Project Review Committee (PRC)  
Agenda

Date: Wednesday, February 16, 2022  
Time: 4:00 p.m.  
Location: <https://www.youtube.com/c/CityofRochesterVideos>

Case Number:	1
File Number:	SP-016-21-22
Case Type:	Major Site Plan Review
Address:	101-113 Franklin St, 106 Pleasant St, 317, and 325 Andrews St
Zoning:	CCD-B Center City Base District
Quadrant	Southwest
Applicant:	Eugenio Marlin, Ibero-American Development Corporation
Request:	To construct a six-story, 14,800 square foot, mixed-use building with a 36-space parking area. When completed the building will offer 76 dwelling units and 2,810 square feet of commercial space. Work scope includes a new curb cut and the resubdivision of the subject properties.
Review Requirement:	120-191D(3)(c)[2] Applications in the CCD that include major deviations from the design criteria.
Enforcement:	No
SEQR:	Unlisted
Lead Agency:	Manager of Zoning
Contact:	Anna Keller, <a href="mailto:siteplanreview@cityofrochester.gov">siteplanreview@cityofrochester.gov</a>

Date: February 16, 2022  
Time: 4:00 p.m.  
Location: <https://www.youtube.com/c/CityofRochesterVideos>  
Topic: 101-113 Franklin St, 106 Pleasant St and 317 and 325 Andrews St  
Members Pre

Sketch Plan	
Drawing Name:	Project No.
Date: 08/31/20	20-0531
Type: MD40	
Drawn By: SLA	SK3
Scale: 1" = 20'	Drawing No.

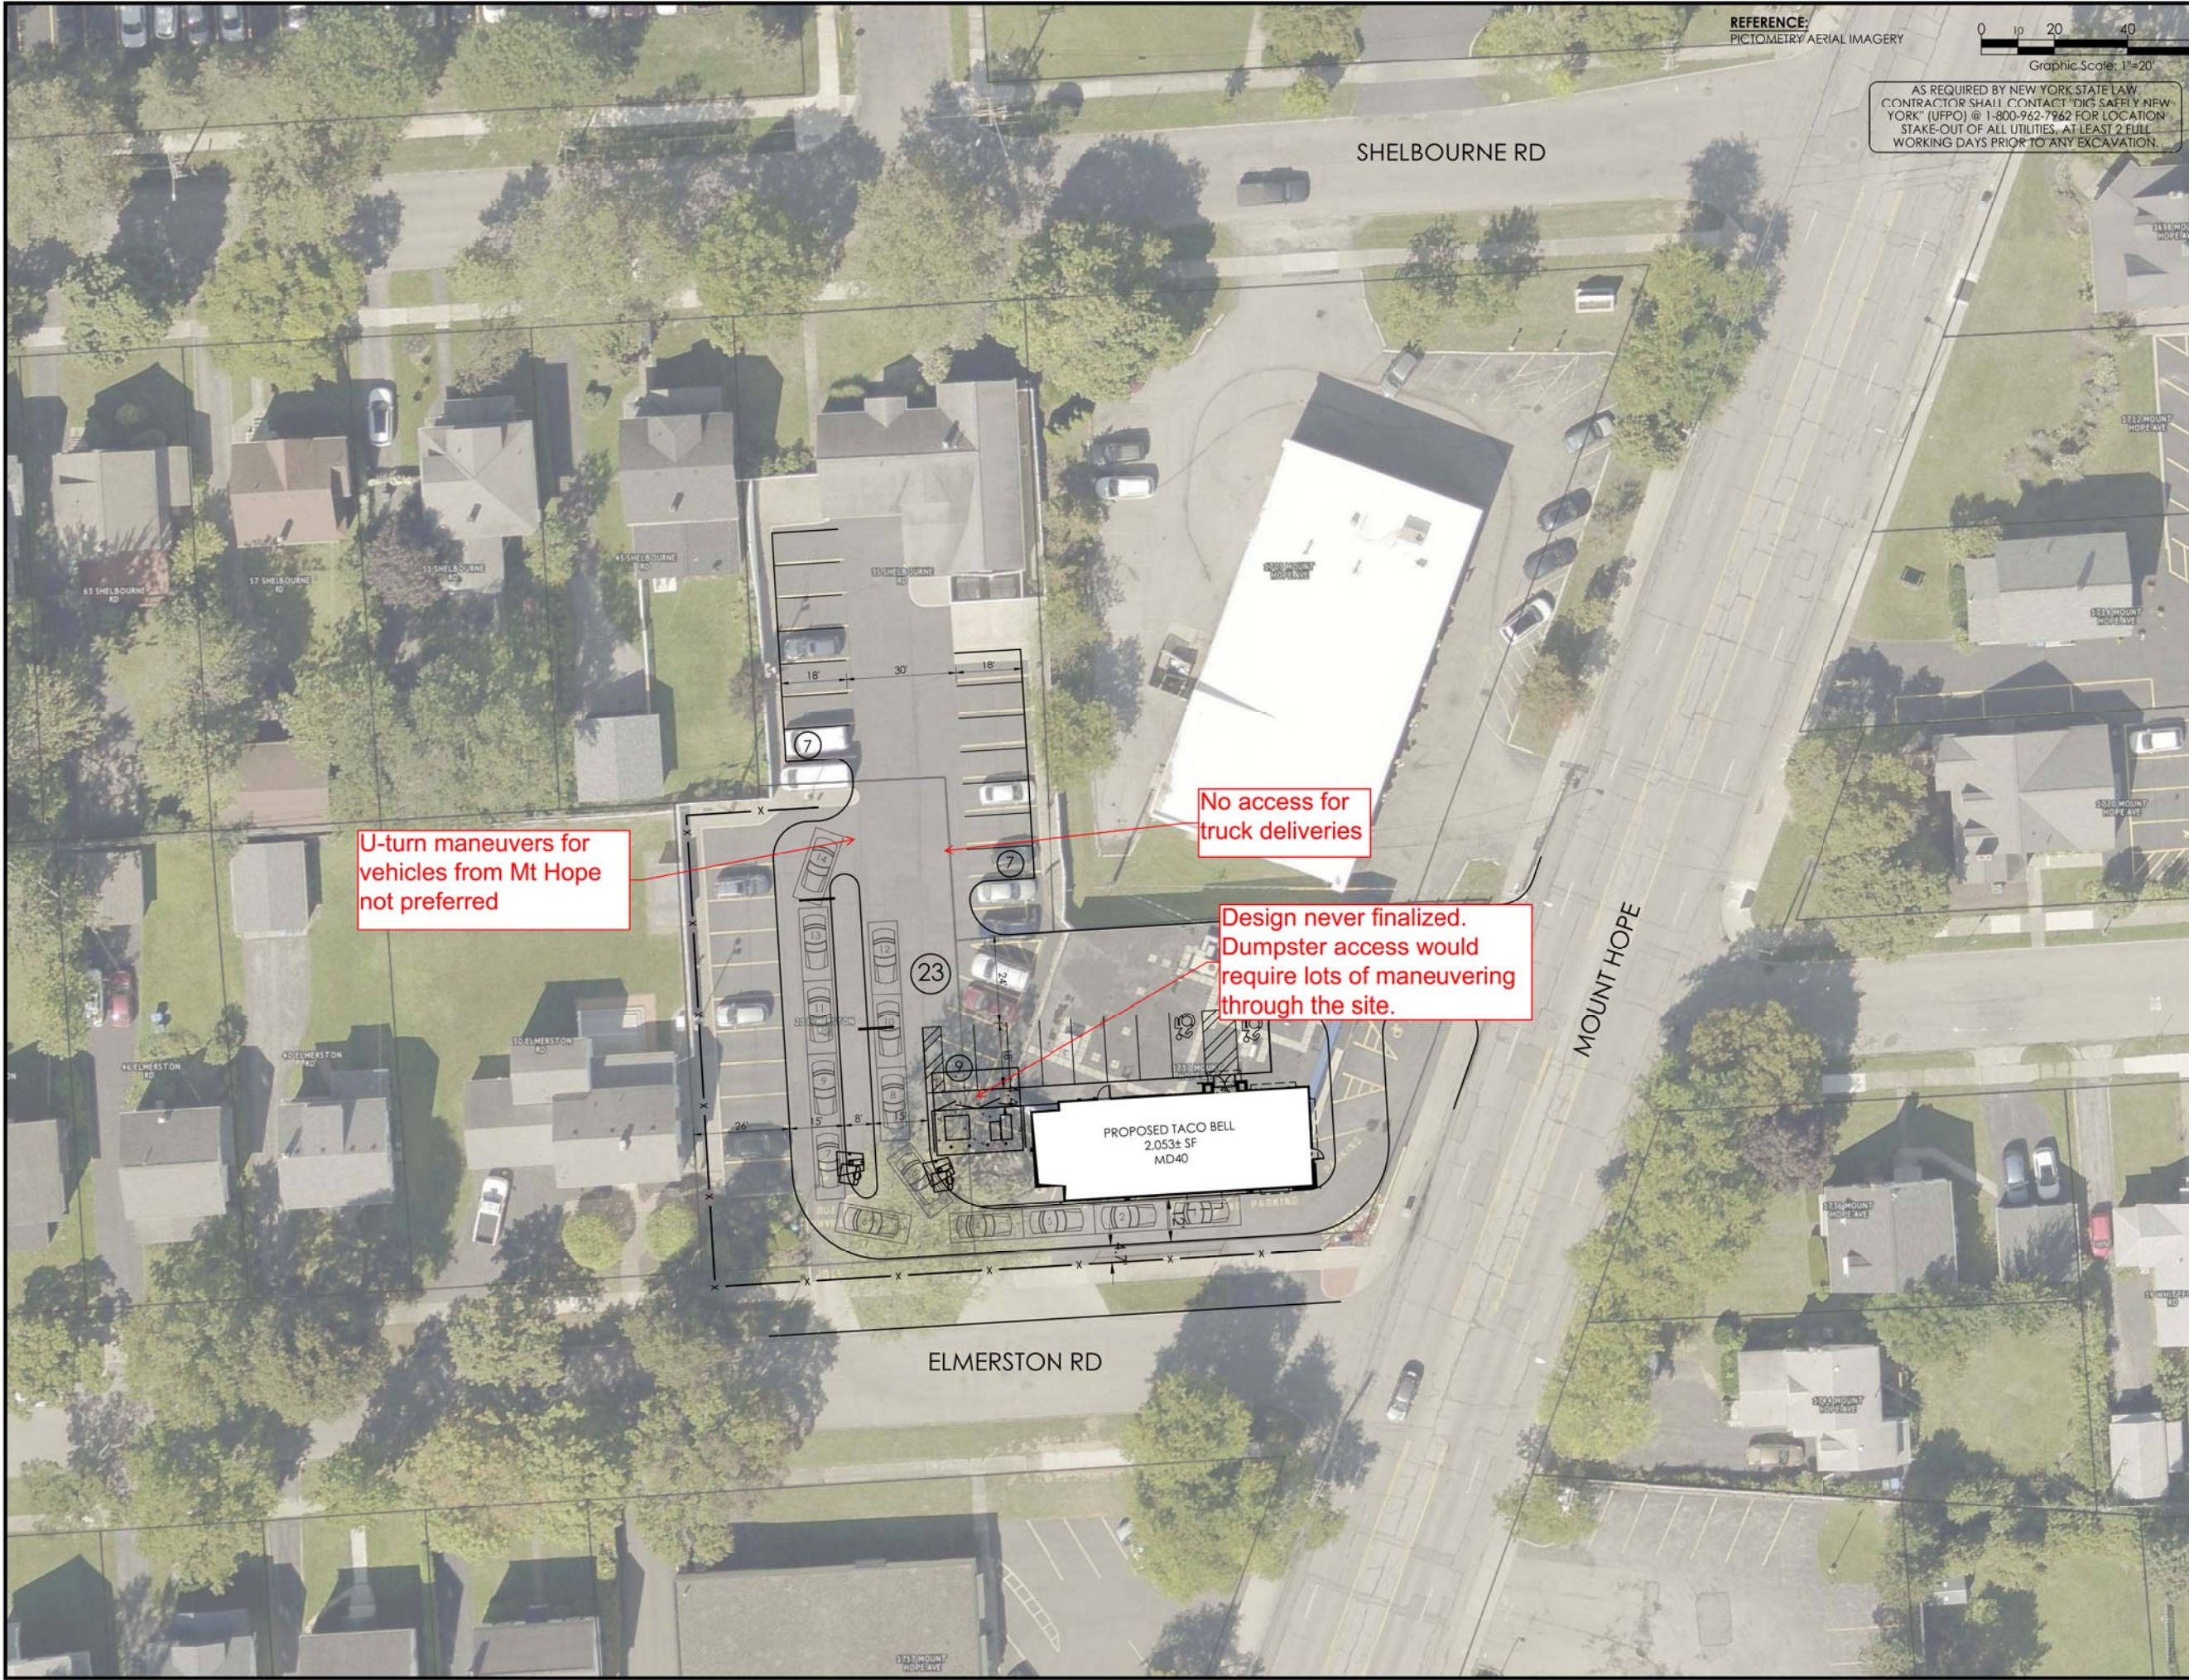
U-turn maneuvers for vehicles from Mt Hope not preferred

Site Plan	
Drawing Name:	Project No.
Date: 07/27/20	20-0531
Type: MD40	
Drawn By: SLA	C2
Scale: 1" = 20'	Drawing No.

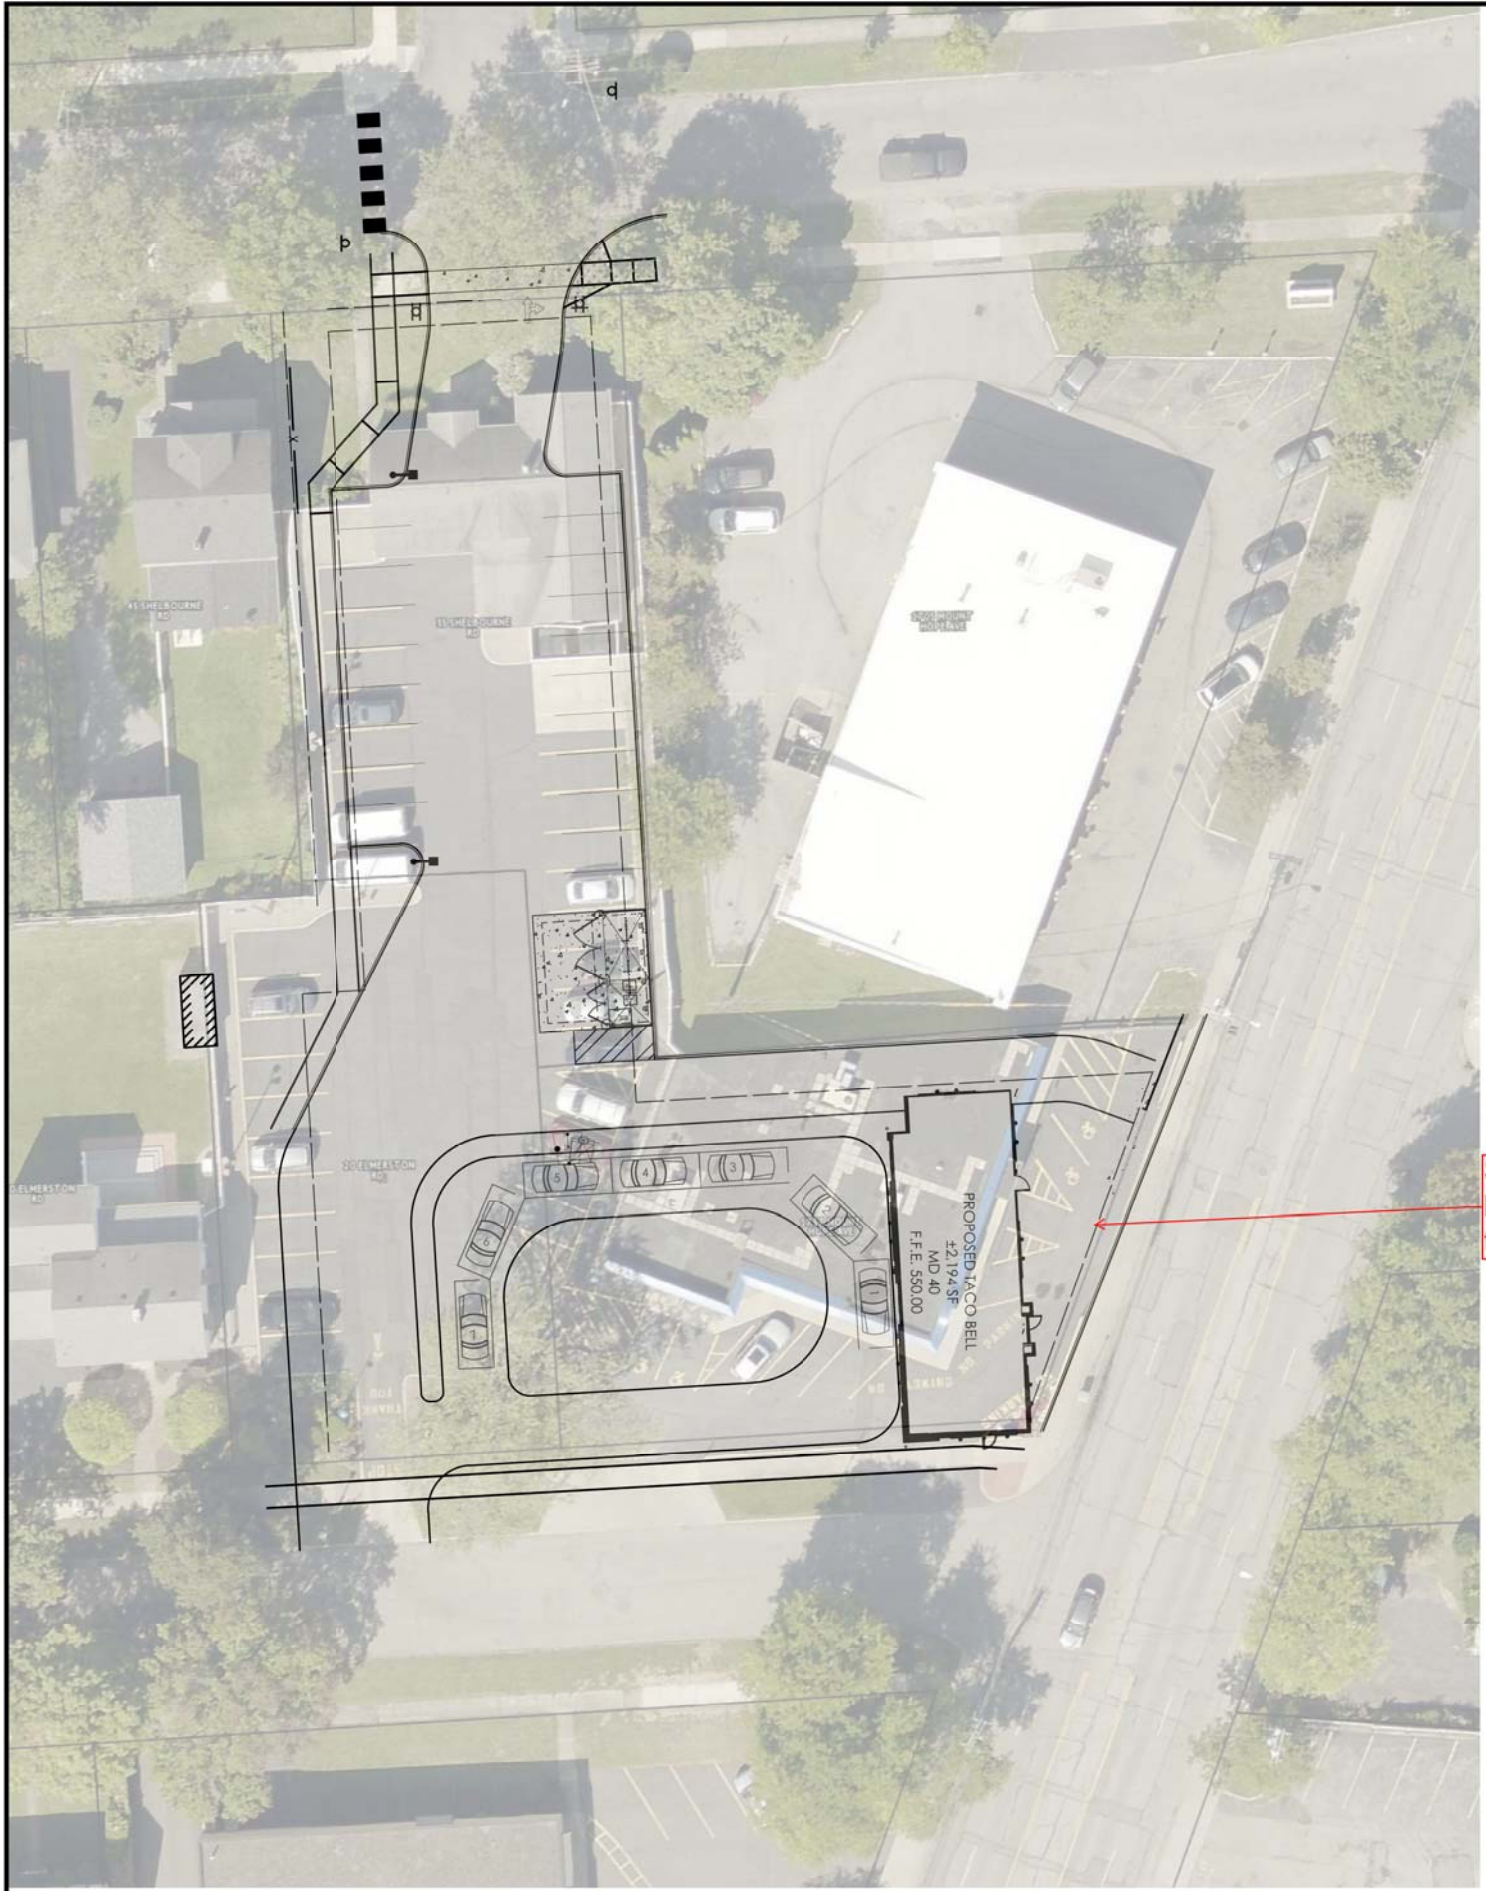
Same general comments as the last plan, but building is rotated along Elmerston and there is less stacking
